**1958 Agreement – Consideration of draft amendments
to existing Regulations submitted by GRE**

Proposal for Supplement 4 to the 01 series of amendments to Regulation No. 113 (Headlamps emitting a symmetrical passing-beam)

Submitted by the Working Party on Lighting and Light-Signalling*

Overview of operational periods concerning test for stability of photometric performance

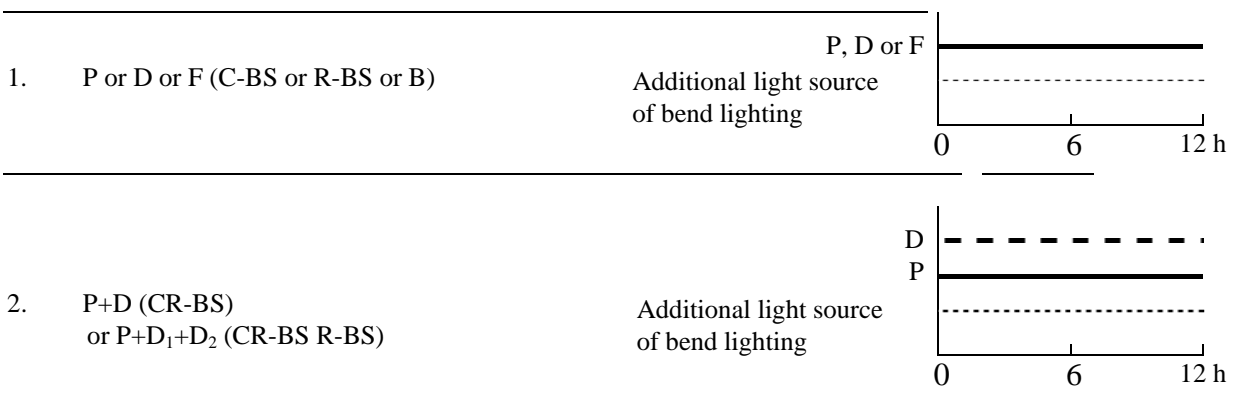
Annex 8, amend to read:

"Annex 8

Abbreviations: P: passing beam lamp

D: driving beam lamp (D₁ + D₂ means two driving beams)

F: front fog lamp

- - - - - : means a cycle of 15 minutes off and 5 minutes lit.

..... : means a cycle of 9 minutes off and 1 minutes lit.
